Application table

Application:	All Astro Hoist with Overload
Reason:	Mandatory Fatigue Inspection of Overload Shaft
Frequency	Inspection: Annually – Replacement: Every 3 Years
Priority:	Mandatory

Background

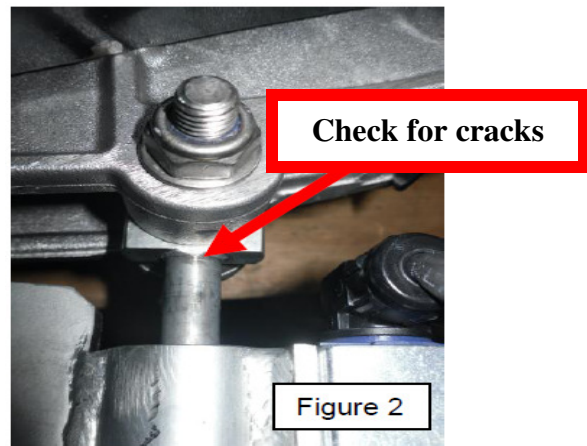
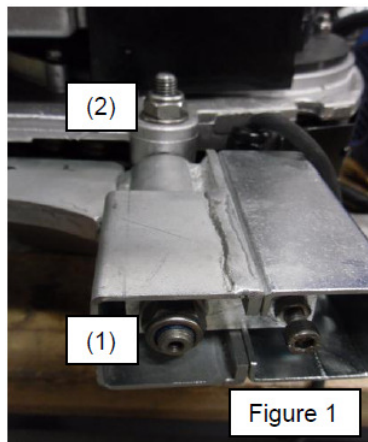
There have been a few reports of the Overload Shaft PN 81.116 breaking due to fatigue. If hoist is being operated at the time of breakage, it will only travel in the downward direction. There are no reports of falling hoists or injuries to operators.

- 1) Put the hoist with the motor facing upward on a table.
- 2) Loosen and remove nut on position (1) (Figure 1) (wrench 17mm)
- 3) Lower the overload and inspect the shaft on indicated location (Figure 2) for any sign of cracks. If there are signs of cracks continue with replacing the shaft.

Inspect Overload Shaft p/n: 81.116 annually for signs of fatigue or cracks and replace every 3 years.

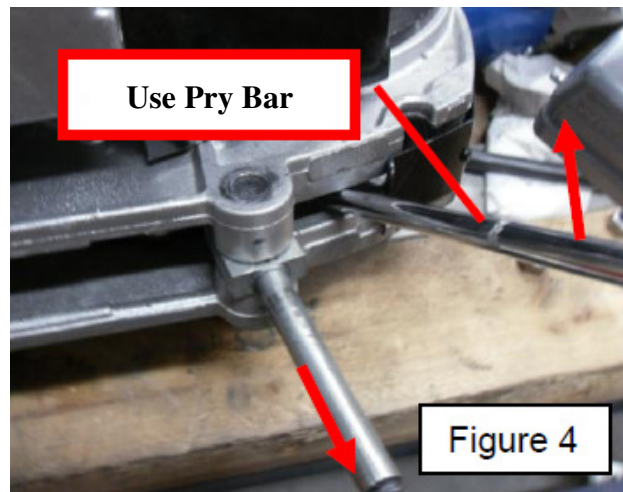
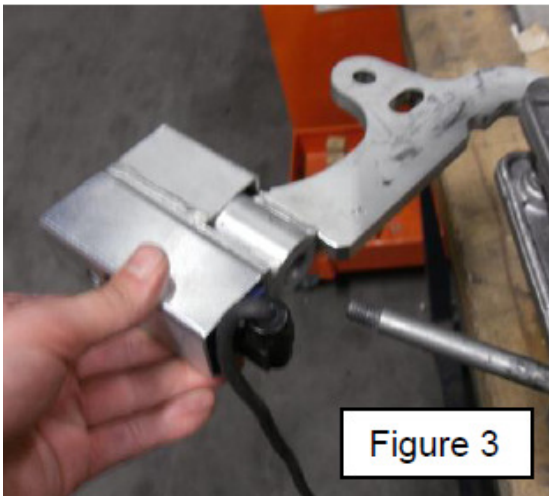
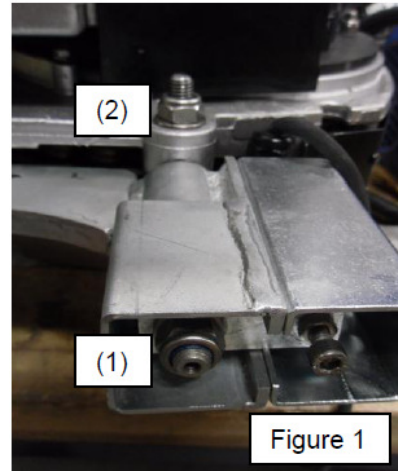
- 1) Loosen and remove nut and bolt on position (2) (Figure 1) (Wrench 17mm and Allen® key 8mm).
- 2) Remove the overload device from the bolt (Figure 3)
- 3) Remove the shaft from the hoist. If needed use a small pry bar to widen the opening to free the shaft with distance bushing (Figure 4)
- 4) Assemble a new shaft with the old distance bushing.
- 5) Tighten nuts (2) and (1) (Figure 1).

- 6) Adjust and test the overload to 125% of Hoist Rated Load

Figure 5

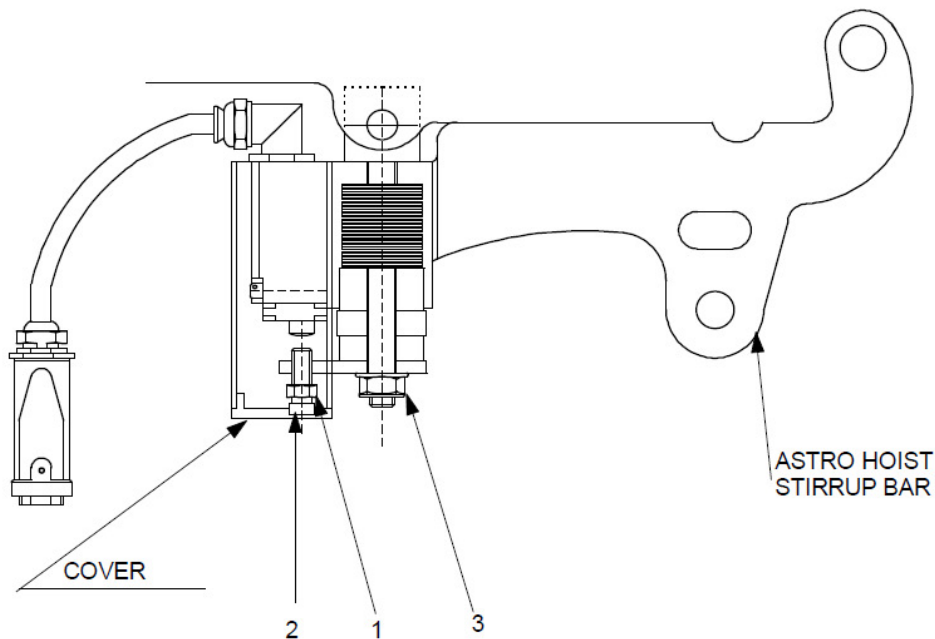
1. Set test stand with 125% of hoist rated load and install hoist on test stand
2. Attempt to lift Load of 125% rated load with hoist power
 - a. If hoist lifts 1" or so and shuts off in up direction proceed to step 9.
 - b. If hoist fails to lift or does not shut off proceed to step 3.
3. Remove cover shown in figure 5.
4. Release lock nut (1) (figure 5).

5. Turn Allen® screw (2) (figure 5) clockwise (upwards) to decrease the overload setting. Turn Allen® screw (2) (figure 5) anti-clockwise (downwards) to increase the overload setting.
6. Secure the Allen® screw again by tightening the lock nut.
7. Fit back the cover shown in figure 5.
8. Repeat step 2
9. **VERIFY COMPLETION OF SETTING THE OVERLOAD**
 - a. **BOTH OF STATEMENTS BELOW MUST BE TRUE**
 - i. Hoist can lift rated load
 - ii. Hoist can **not** lift 125% of rated load.
 - b. **If not true repeat steps 3-8**

- Make sure nut (3) (figure 5) on Overload shaft is secure before attempting Overload adjusting and testing.
- Adjustment to the required setting must be done with testing weights in order to be certain of precise overload protection available.
- Setting is recommended at 125% of Hoist Rated Load limit (for one hoist), but must always be checked against local regulations.
